# TECHNICAL SERVICE BULLETIN

## Turn Signal Lamps Inoperative After LED Control Module Replacement

**21-2195**  
28 June 2021

Ford 2020-2021 Explorer
----------------------------

Figure 1 - Left side

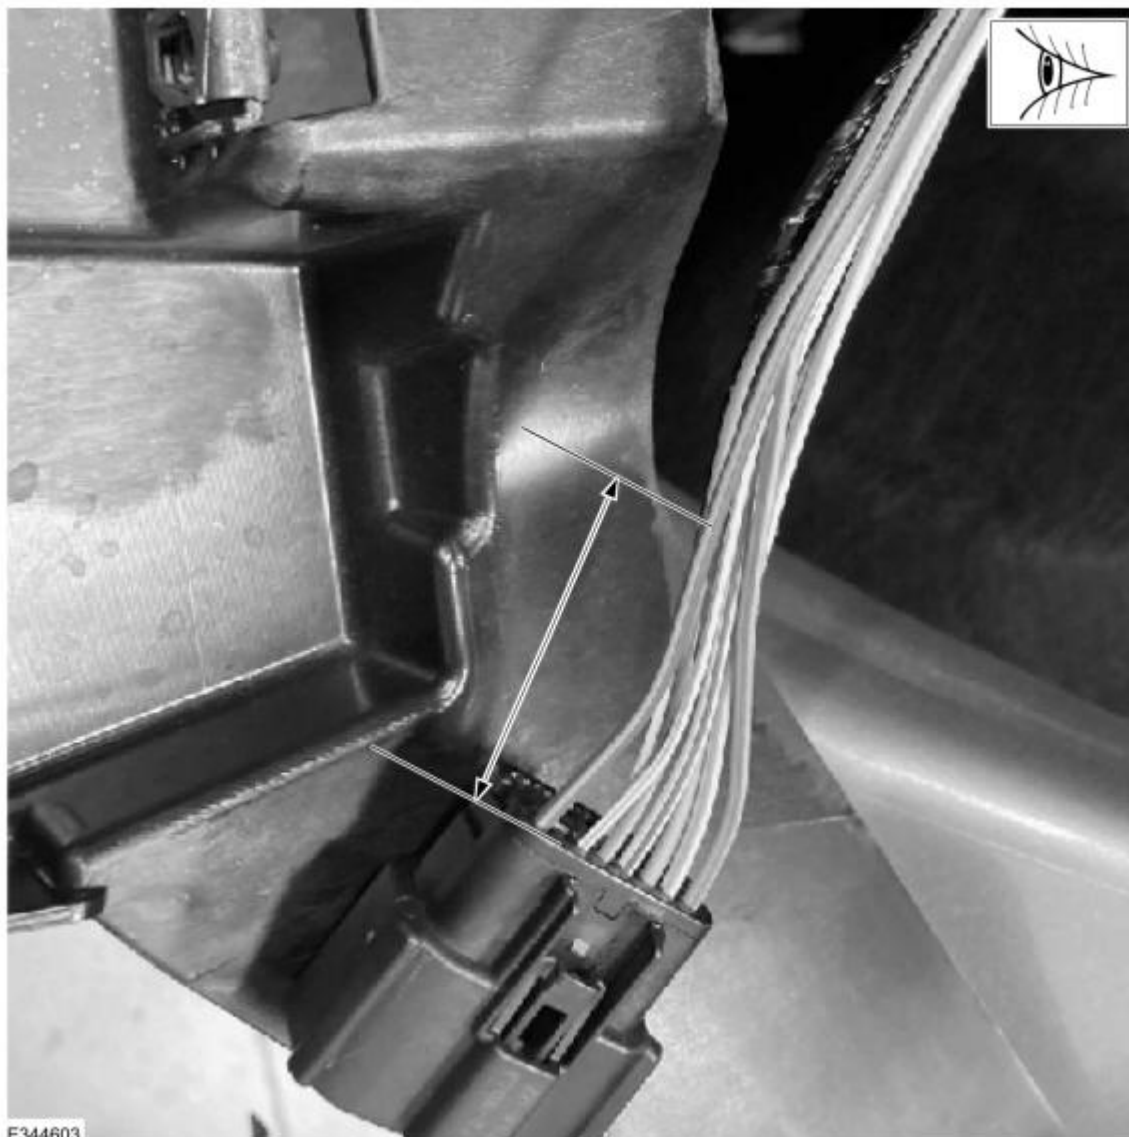
1. Remove the affected headlamp assembly. Refer to Workshop Manual (WSM), Section 417-01.
2. For vehicles where the left side is affected, update the left side wiring.
  - (1). Remove 2 wiring terminals from the wiring service pigtail connector.

- (2). Install the terminals into connector C1284, pins 9 and 14. Refer to Wiring Diagram, Cell 085-4.
- (3). Cut the wire to circuit GD120, pin 8 on connector C1284, 76.2 mm (3 in.) from the connector.
- (4). Solder splice wires from pins 8, 9, and 14 to circuit GD120. Refer to Wiring Diagram, Cell 005. (Figure 1)

Figure 2 - Right side

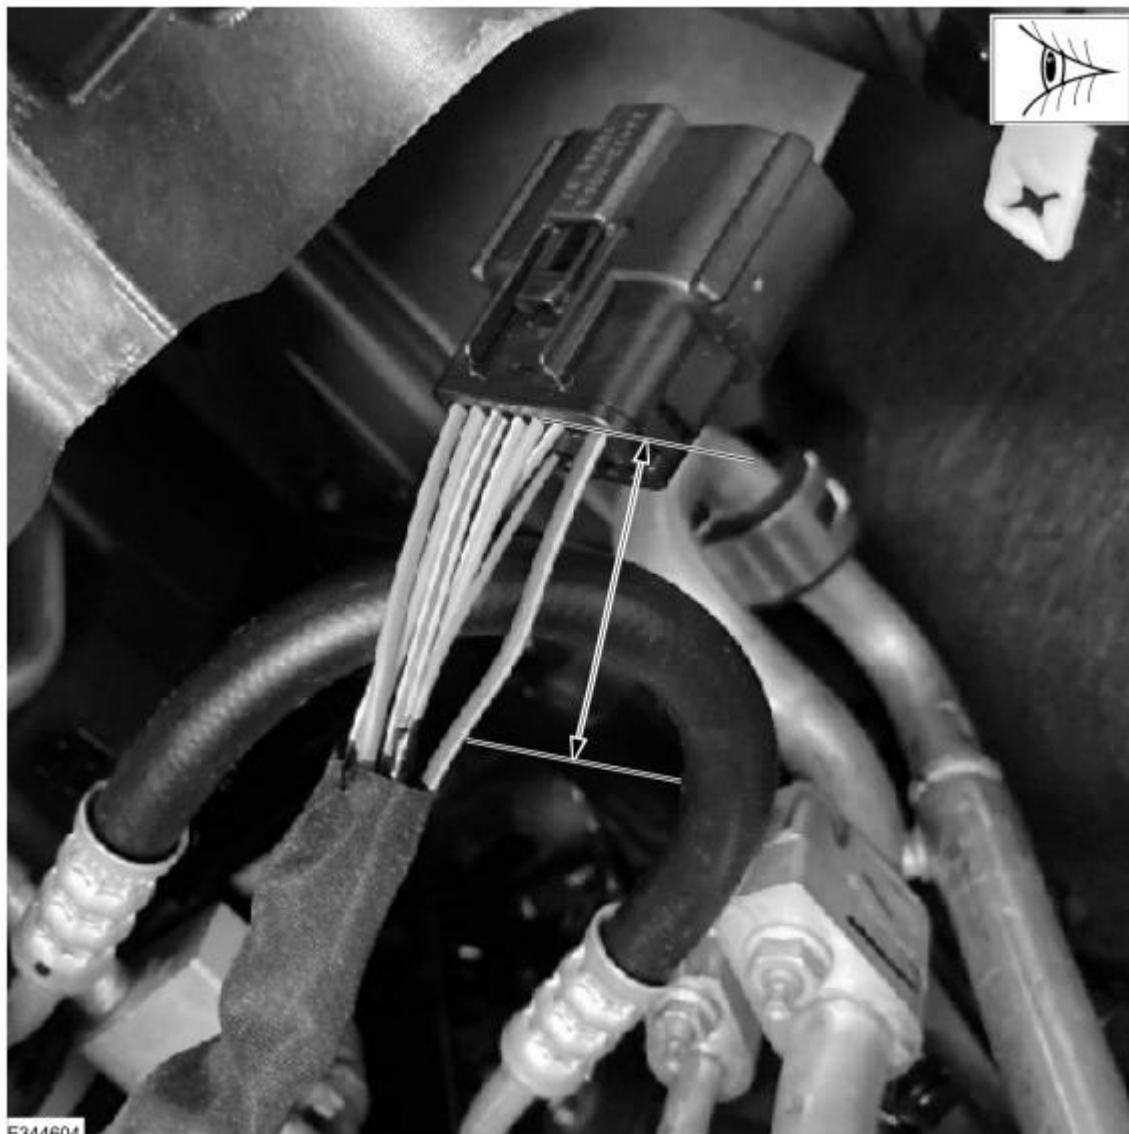
**3.** For vehicles where the right side is affected, update the right side wiring.

- (1). Remove 1 wiring terminal from the wiring service pigtail connector.
- (2). Install the terminal into connector C1285, pin 9. Refer to Wiring Diagram, Cell 085-5.
- (3). Cut the wire to circuit CLF03, pin 2 on connector C1285, 76.2 mm (3 in.) from the connector.
- (4). Solder splice wires from pins 2 and 9 to circuit CLF03. Refer to Wiring Diagram, Cell 005. (Figure 2)
